World Forum for Harmonization of Vehicle Regulations

**Consideration of draft amendments to existing UN Regulations
submitted by GRSP**

Proposal for Supplement 2 to the 03 series of amendment to UN Regulation No. 127 (Pedestrian safety)

Submitted by the Working Party on Passive Safety *

Figure 12
Windscreen Test Area

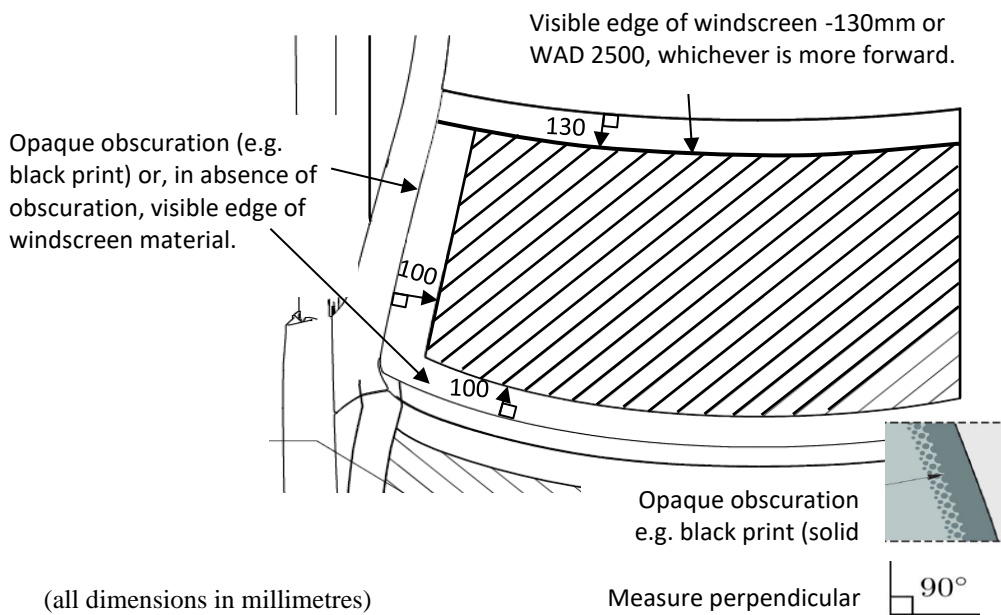
Paragraph 2.44., amend to read and insert Figures 12 and 13:

"2.44. "Windscreen test area" is an area on the outer surface of the windscreen. It is bound (see figure 12):

- (a) In the front, by a line 100 mm rearward to the opaque obscuration of the windscreen. In case of absence of the opaque obscuration, the line is measured from the front visible edge of the windscreen material.
- (b) In the rear, by a WAD 2,500 or a line 130 mm forward to the rear visible edge of the windscreen material, whichever is more forward at a given lateral position.
- (c) At each side, by a line 100 mm inside the opaque obscuration of the windscreen. In case of absence of the opaque obscuration, the line is measured from the side visible edge of the windscreen material.

For (a) and (c): the distances of 100 mm are to be measured with a flexible tape held tautly along the outer surface of the vehicle at an angle of 90° to the tangent line to the opaque obscuration limit or in case of absence of the opaque obscuration, from the visible edge respectively.

For (b): the distances of 130 mm is to be measured with a flexible tape held tautly along the outer surface of the vehicle at an angle of 90 ° to the tangent line to the rear visible edge of the windscreen.

Figure 13
Upper Corner Definition with "Shortest Distance"

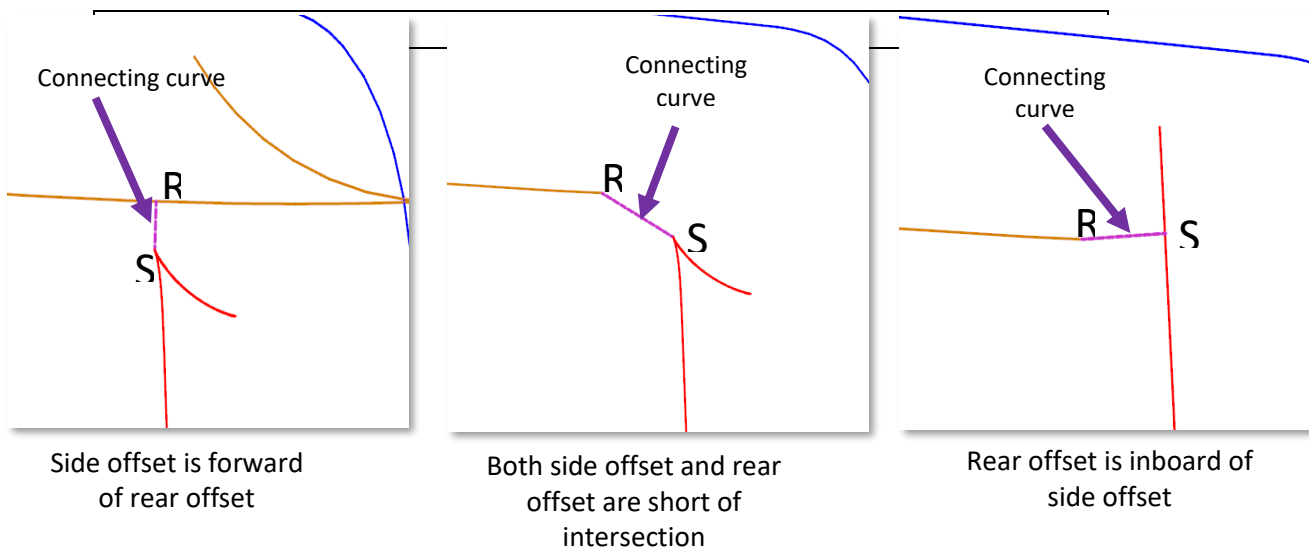
Depending on the geometry, in case there is no intersection between (b) and (c), resulting in an open test area, then the marking shall be modified using the shortest distance to close the open test area (see figure 13).

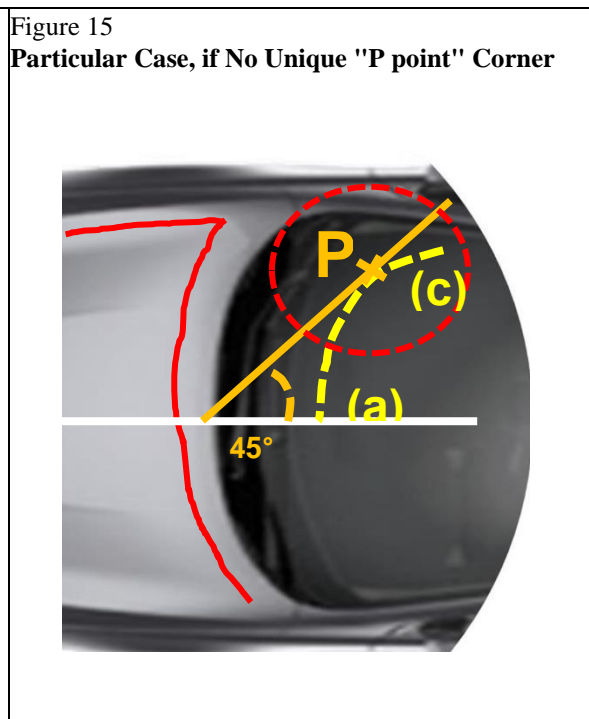
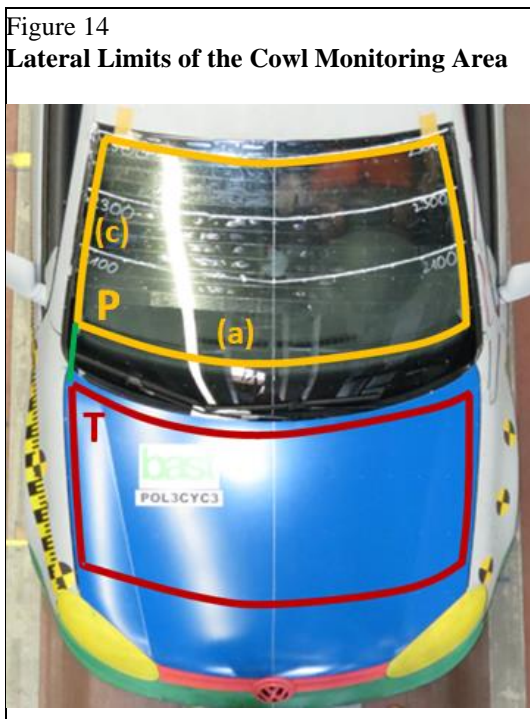
Paragraph 2.45., insert Figures 14 and 15 and amend to read:

At each side, the cowl monitoring area is bound by the TP line (see figure 14), where:

- (a) the "T point" is the rear corner of the bonnet top test area; and
- (b) the "P corner point" is the lower corner of the windscreen test area; using a flexible tape held tautly from point T to P.

If there is no unique "P point" where the lines defined in 2.44 (a) and (c) intersect, then the "P point" is defined by the first contact of a vertical plane intersecting the vertical longitudinal vehicle centre-plane at an angle of 45° with the (a)-(c) transition of the windscreen test area boundary, as shown in Figure 15.

Figure 16
Jerk Criterion Graph and Formula

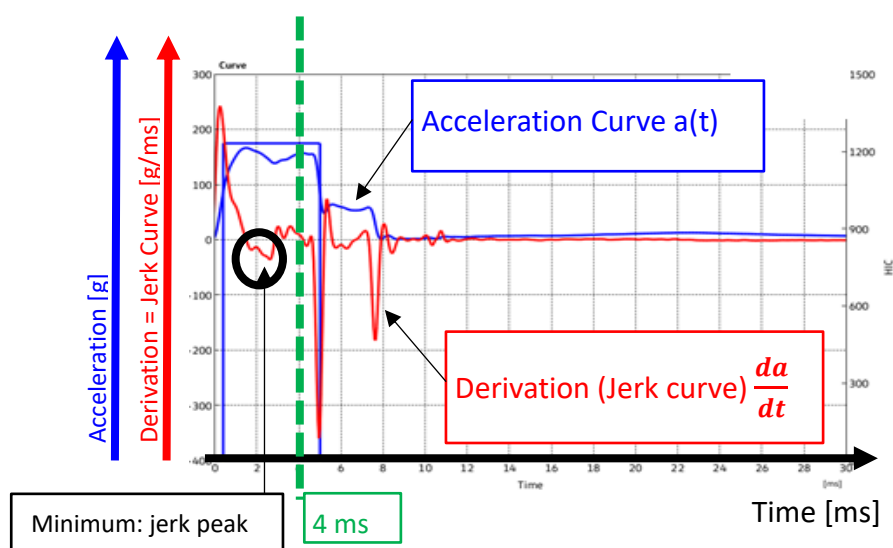
Paragraph 2.48., insert Figure 16 and amend to read:

- (a) The absolute value of the minimum value of the derivation of the headform acceleration versus time is less than 180 g/ms within the first 4 ms after the initial contact of the headform to the windscreen, as shown in Figure 16 ; or

$$\left| \min \left(\frac{da}{dt} \right) \right| < 180 \text{g/ms, for } 0 < t < 4 \text{ms}$$
